**Project Name: UNIVERSITY OF CALIFORNIA, MERCED
CLASSROOM AND OFFICE BUILDING 1 RENOVATION**

Project No.: 908078

ADDENDUM NO. 1
to the
CONTRACT DOCUMENTS
March 18, 2020

SYMBOL LEGEND, GENERAL NOTES, ABBREVIATIONS, DRAWING INDEX. Includes 'Drawn By: RC', 'Checked By: RC', 'Project Number: 2019031', and 'Sheet Number: E0.01'.

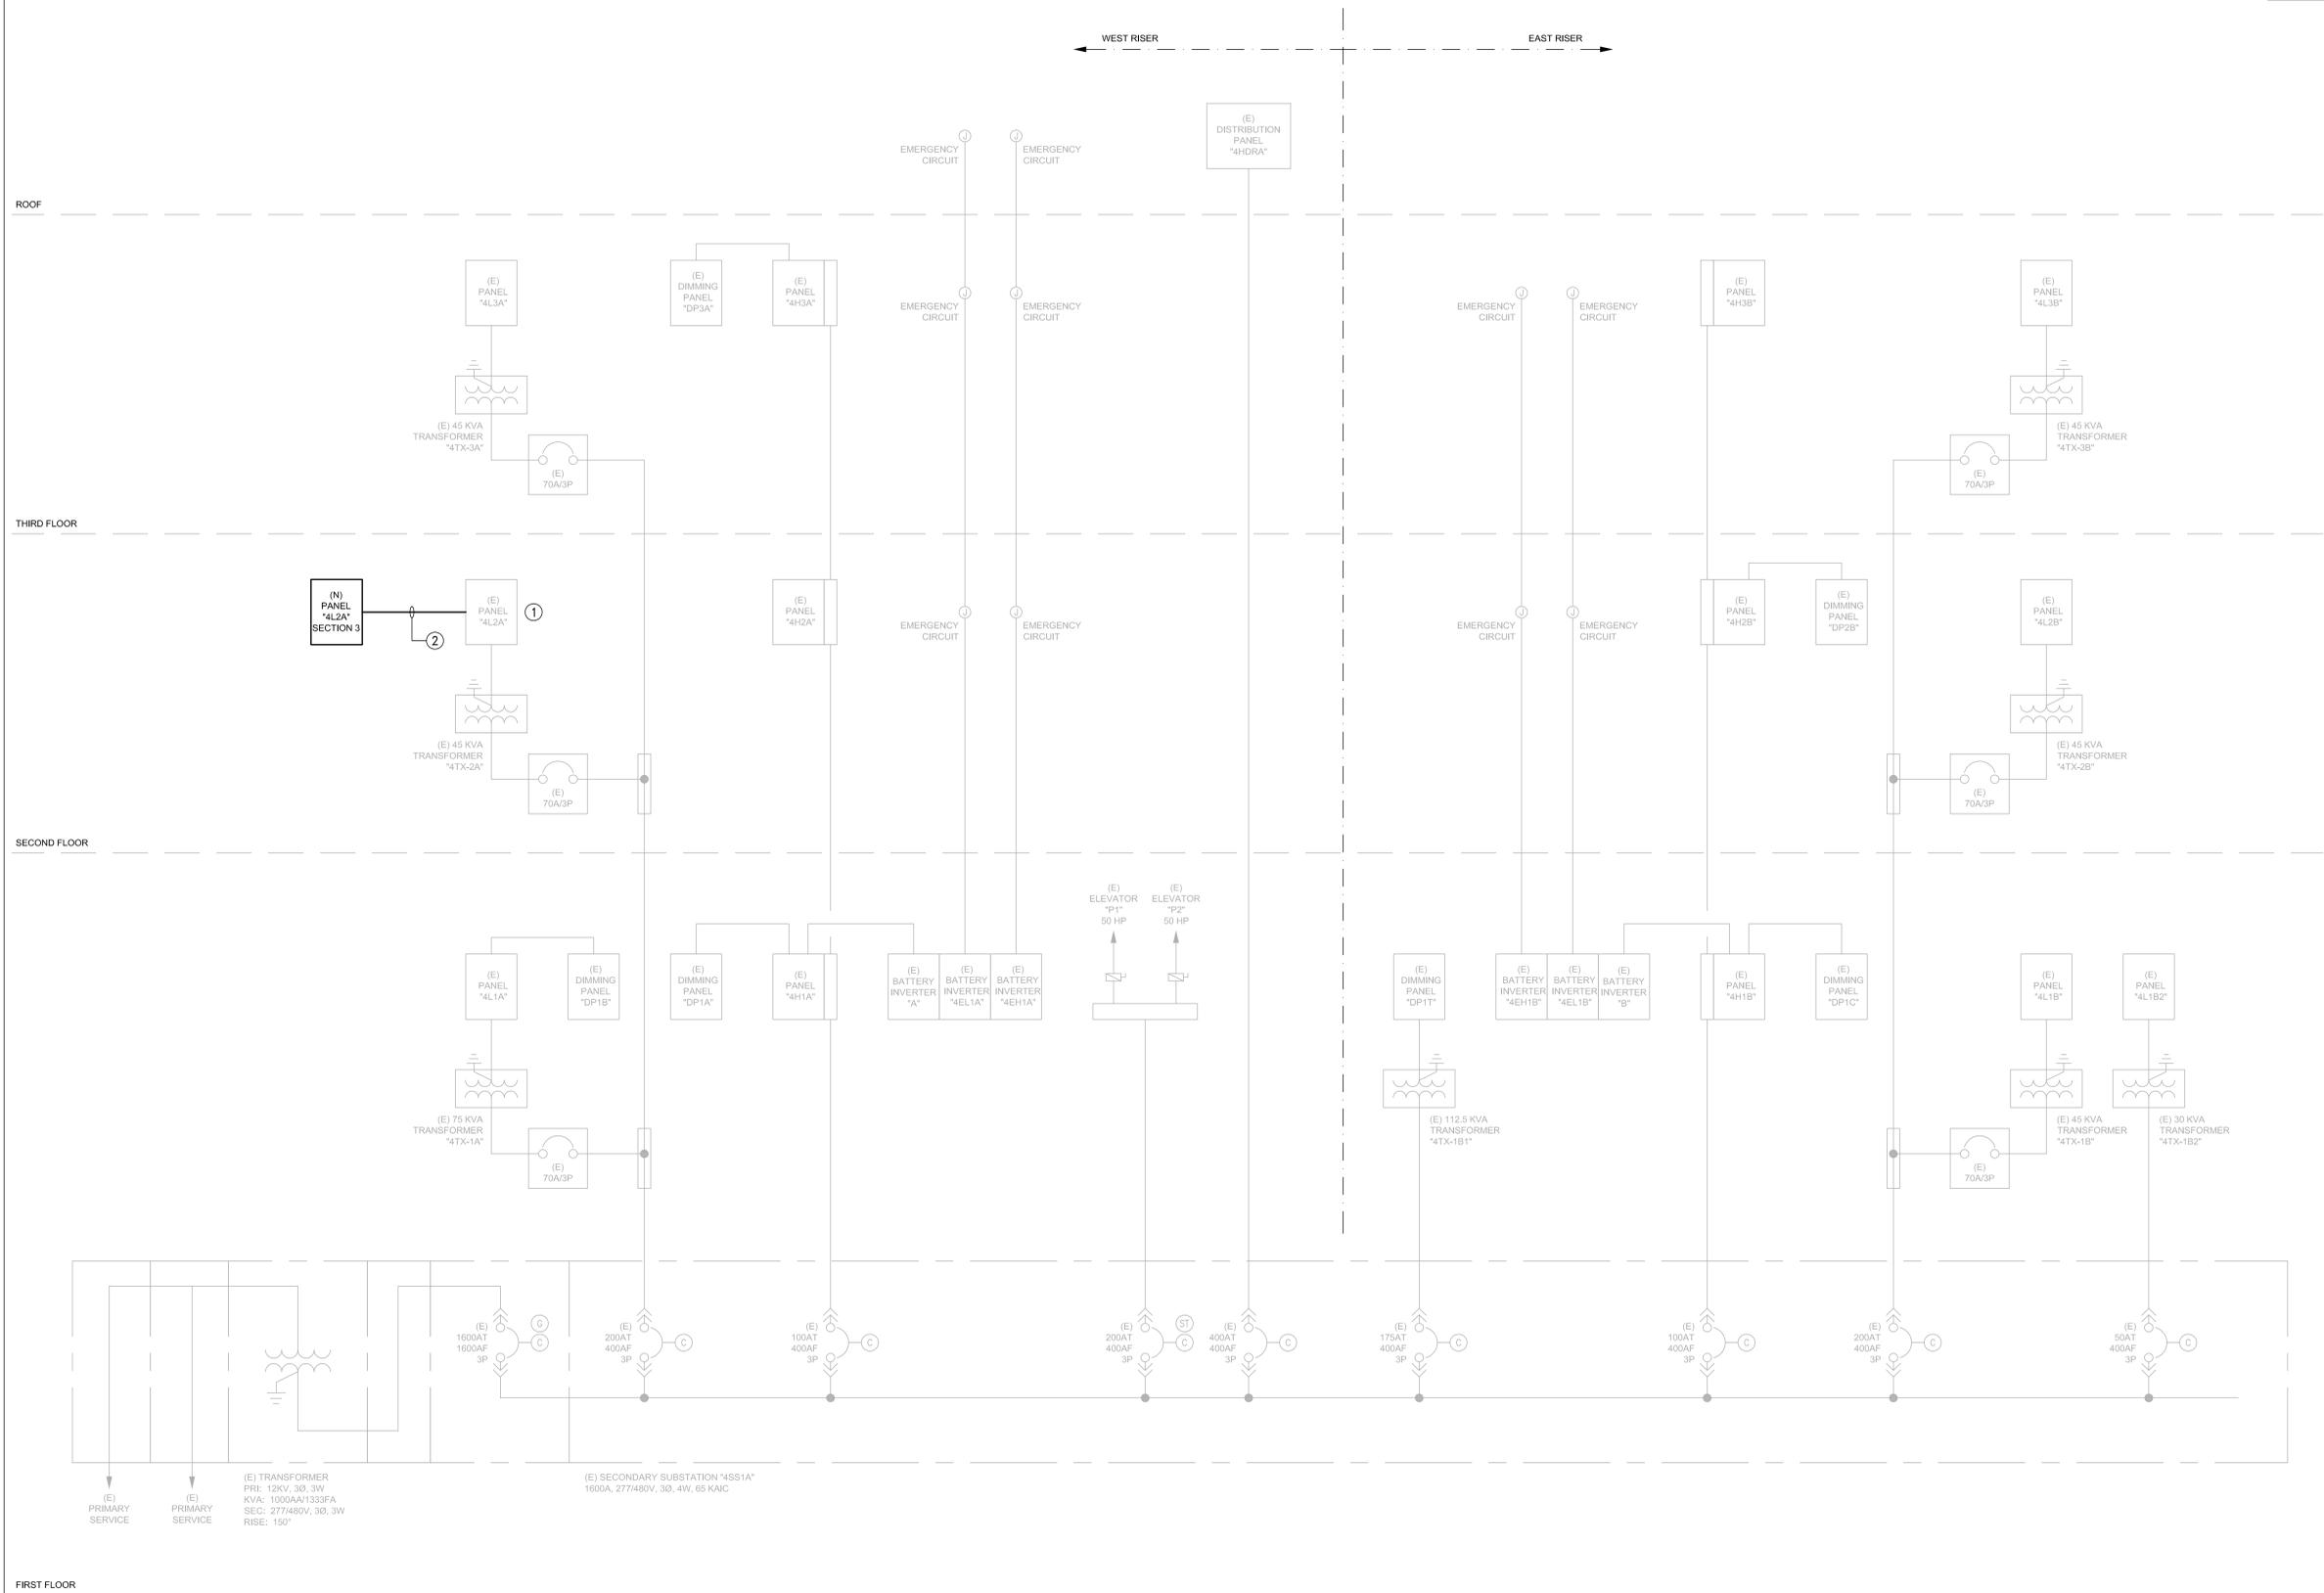
E0.01	SYMBOL LEGEND, GENERAL NOTES, ABBREVIATIONS, DRAWING INDEX	<ol style="list-style-type: none"> 1. Revised description for Lutron Vive system symbols. 2. Revised description for data outlet. 3. Revised description for A/V outlet. 4. Revised description for flush mounted floor box for furniture system. 5. Added symbol legend for fire/smoke damper, fire alarm relay module, "FSR" A/V box with devices, flush mounted floor box for power, and flush mounted floor box for data. 6. Revised Drawing Index.
E0.02	SINGLE LINE DIAGRAM	<ol style="list-style-type: none"> 1. Added Exit Sign in Lighting Fixture Schedule. 2. Updated Title 24 compliance forms.
E0.03	TITLE 24, LIGHTING FIXTURE SCHEDULE	<ol style="list-style-type: none"> 1. Added Exit Sign in Lighting Fixture Schedule. 2. Updated Title 24 compliance forms.
E0.03 ALT 2	TITLE 24 - ALTERNATE 2	
E0.04	PANEL SCHEDULES	<ol style="list-style-type: none"> 1. Updated schedule for "4L2A" section 3, "4L3A" section 1, and "4L3A" section 2.

Sheet Number: **E1.03C**

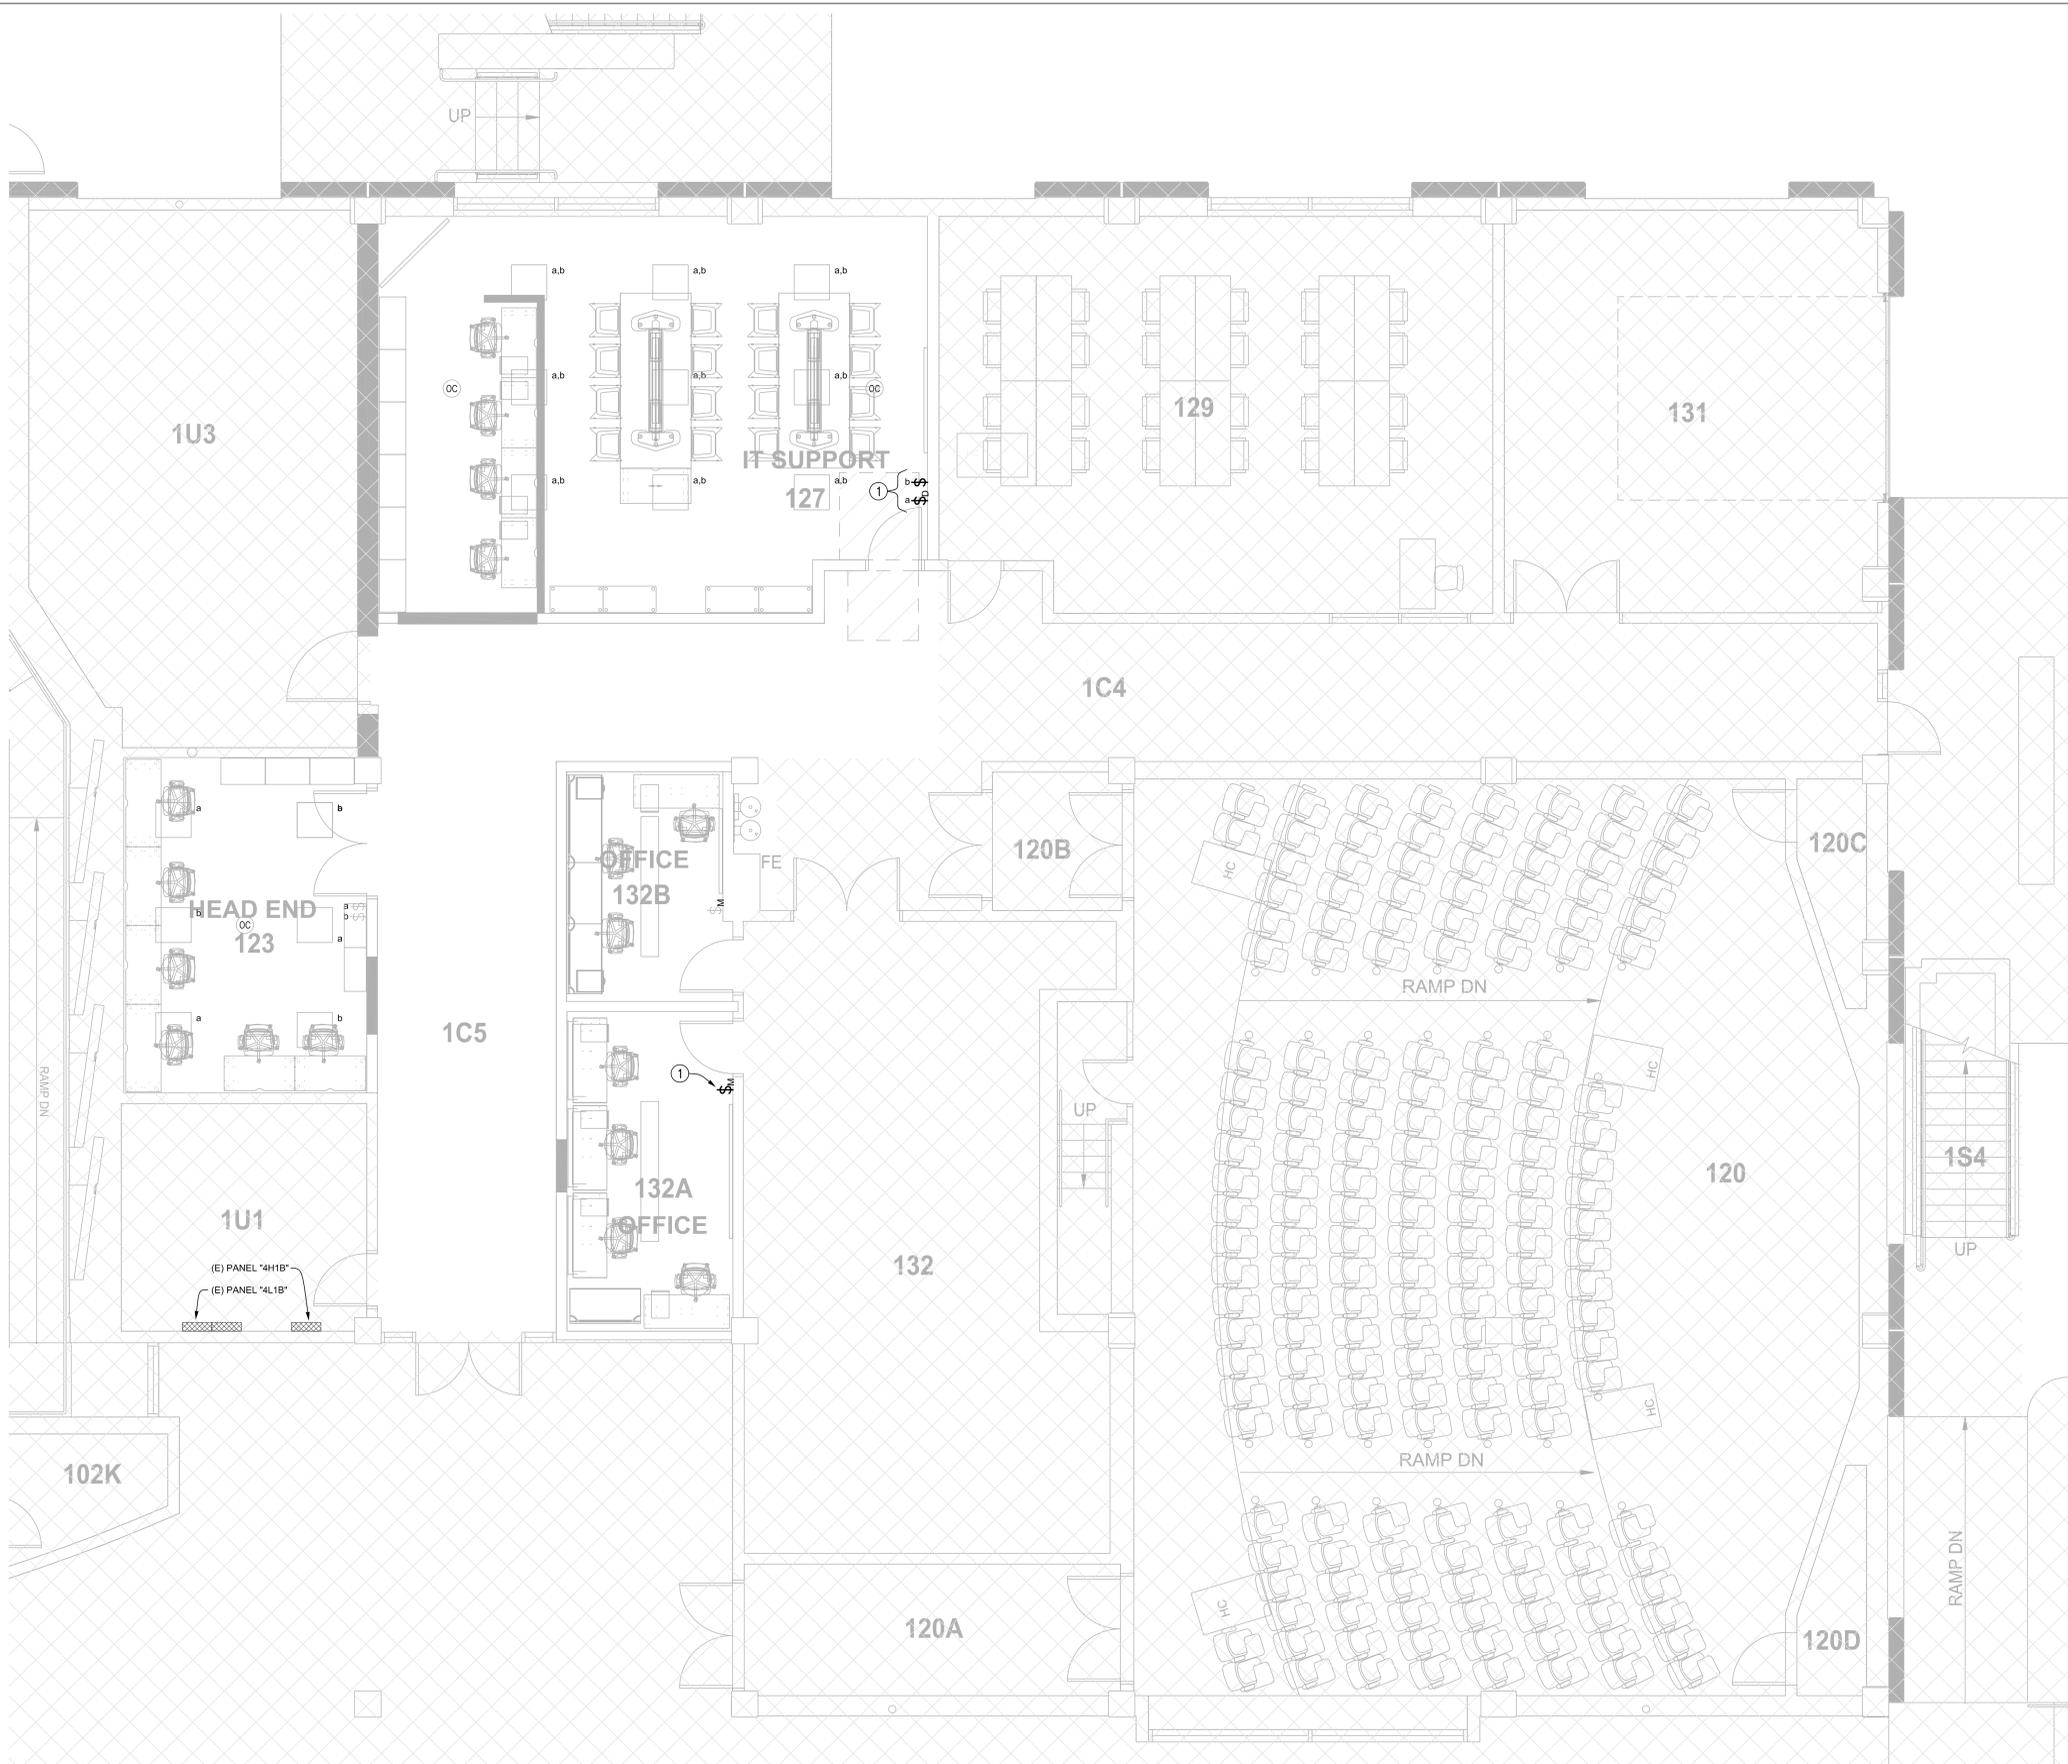
E1.03C	THIRD FLOOR AREA C ELECTRICAL DEMOLITION PLAN	<ol style="list-style-type: none"> 1. Revised work at existing floor boxes. 2. Revised Sheet Note No.1, 4 & 5.
E2.01A	FIRST FLOOR AREA A ELECTRICAL NEW PLAN	
E2.02C	SECOND FLOOR C AREA C ELECTRICAL NEW PLAN	<ol style="list-style-type: none"> 1. Revised work per new space layout. 2. Revised sheet notes.
E2.02D	SECOND FLOOR D AREA D ELECTRICAL NEW PLAN	<ol style="list-style-type: none"> 1. Revised work per new space layout. 2. Revised sheet notes.
E2.03A	THIRD FLOOR AREA A ELECTRICAL NEW PLAN	<ol style="list-style-type: none"> 1. Added Sheet Note No.8.

Sheet Number: **E2.03A ALT 2**

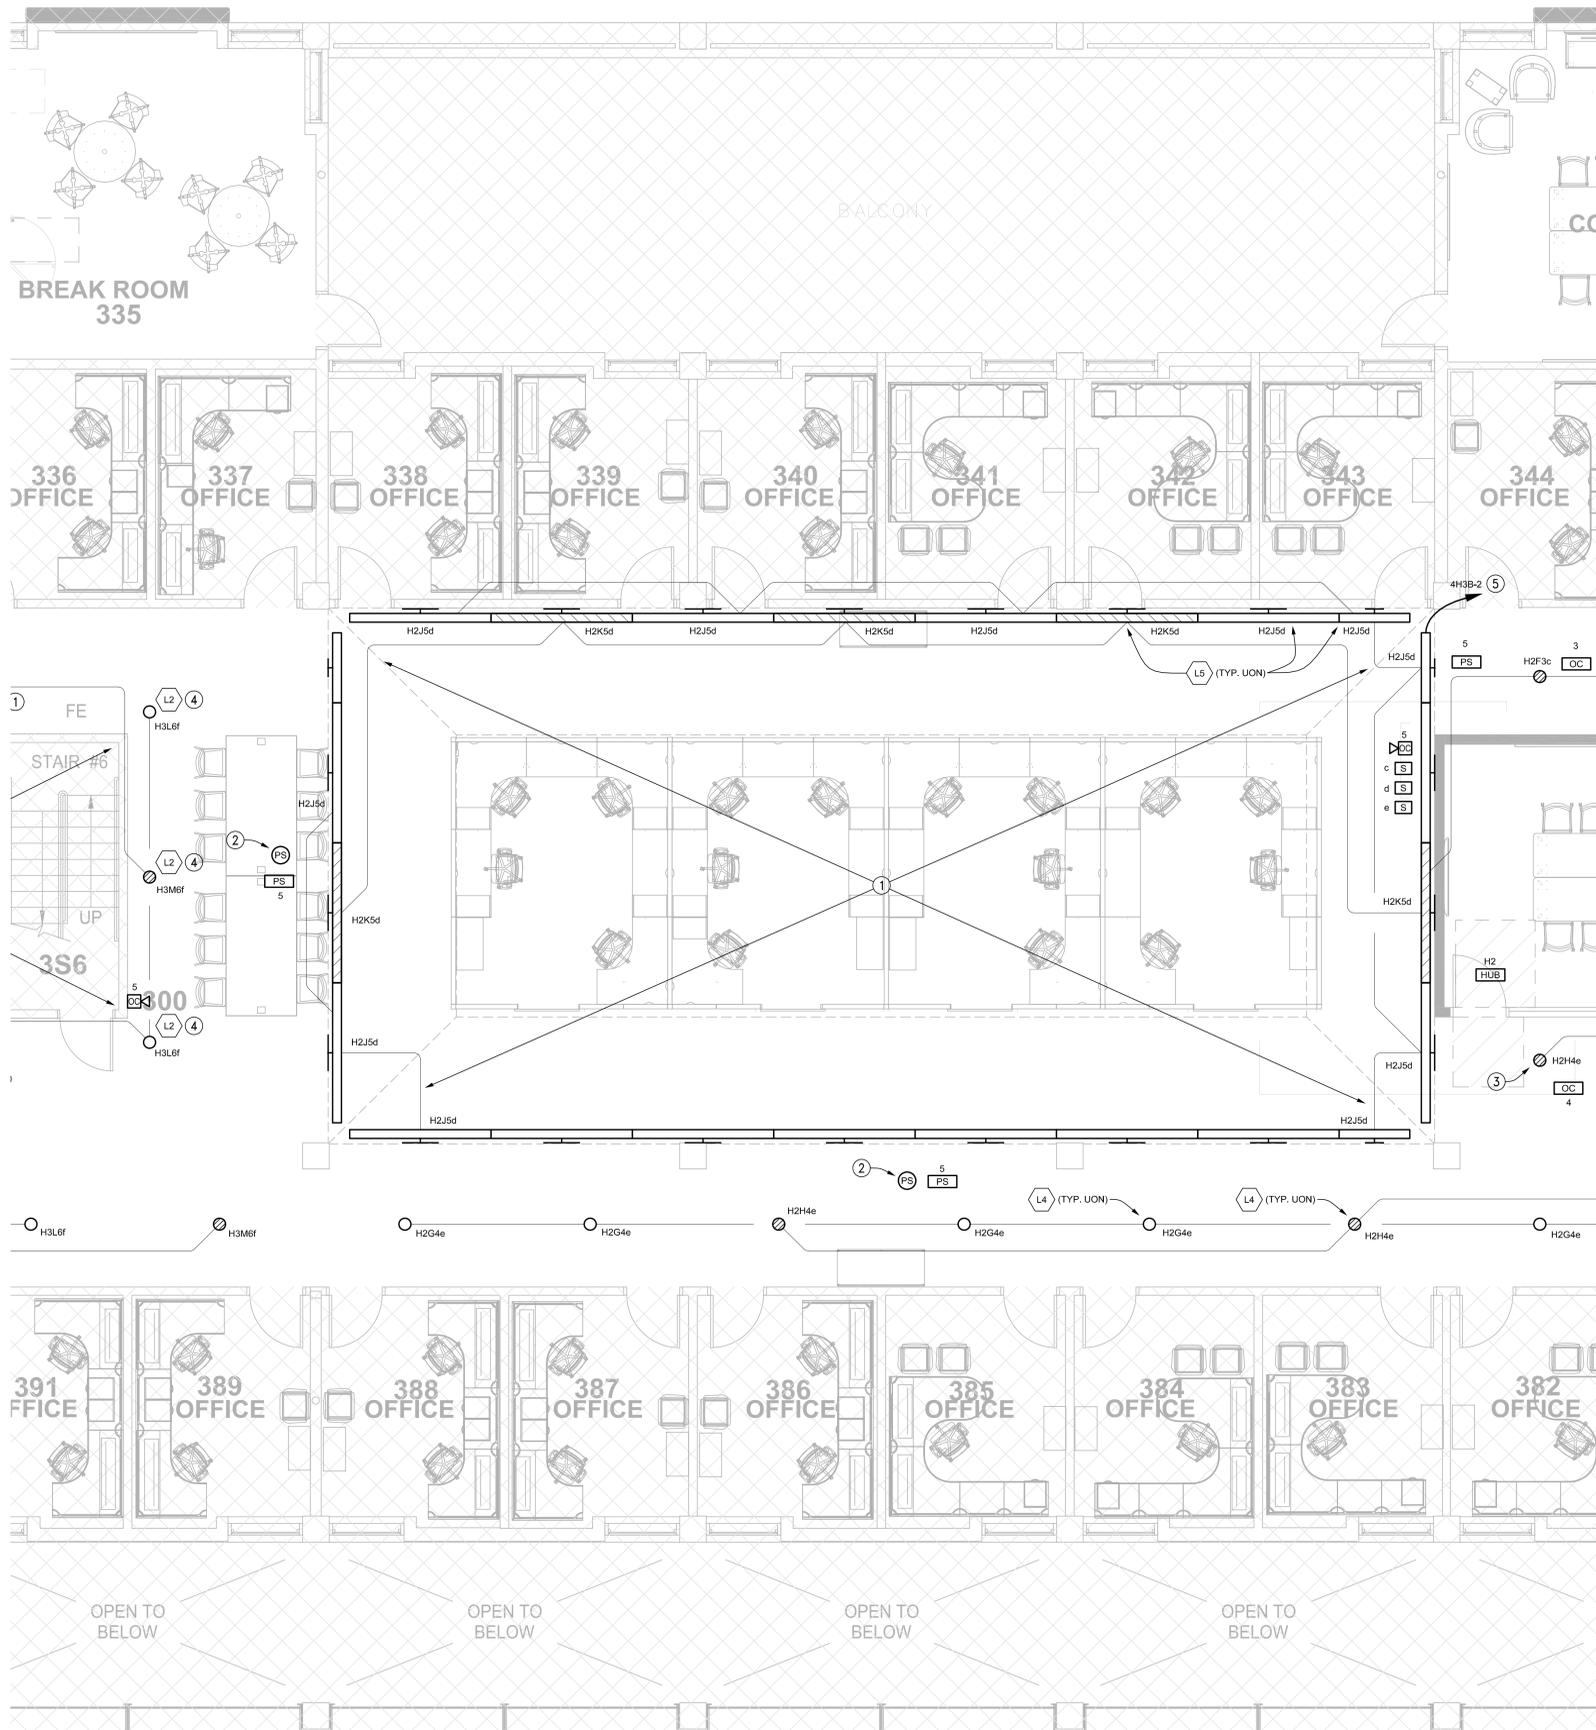
E2.03B	THIRD FLOOR AREA B ELETRICAL NEW PLAN	1. Added Sheet Note No.9.
E2.03C	THIRD FLOOR AREA C ELETRICAL NEW PLAN	1. Added Sheet Note No.4.
E2.03A ALT 2	THIRD FLOOR AREA A NEW LIGHTING PLAN - ALTERNATE 2	1. Revised symbol descriptions. 2. Revised General Notes No. 1 & 2. 3. Revised Sheet Notes No.4.
E2.03B ALT 2	THIRD FLOOR AREA B NEW LIGHTING PLAN - ALTERNATE 2	1. Revised symbol descriptions. 2. Revised General Notes No. 1 & 2.
E2.03C ALT 2	THIRD FLOOR AREA C NEW LIGHTING PLAN - ALTERNATE 2	1. Revised symbol descriptions. 2. Revised General Notes No.1 & 2. 3. Revised Sheet Notes No.3.
E3.01A	FIRST FLOOR AREA A NEW POWER & SIGNAL PLAN	1. Deleted one fourplex receptacle in room 132A. 2. Relocated a ""FSR"" A/V box from facing room 127 to facing corridor. 3. Deleted two fourplex receptacles and two data outlets from new wall in room 127. 4. Added new data outlet in northwest corner in room 127. 5. Revised work at ""FSR"" A/V box on east wall. 6. Revised Sheet Notes No.1 & 2 and Added No.3.
